JORDAN SPRINGS EAST VILLAGE CENTRE, NSW

BCA COMPLIANCE ASSESSMENT REPORT

DATE: 4 NOVEMBER 2019 REPORT NO: 1328 – REV C **FINAL**

PREPARED BY: J2 CONSULTING ENGINEERS | BCA CONSULTING

Figure 3 - FRL 240/240/240 to apply to entire storey

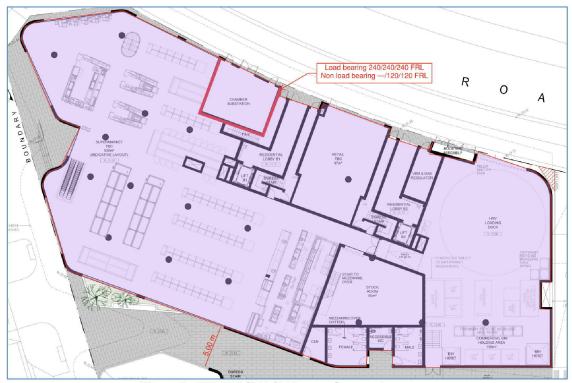
3.1(a)	Fire resistance of building elements	Noted	Refer table 3 extract below.
3.1(b)	External walls, lift pits	Noted	Required to be non-combustible construction.
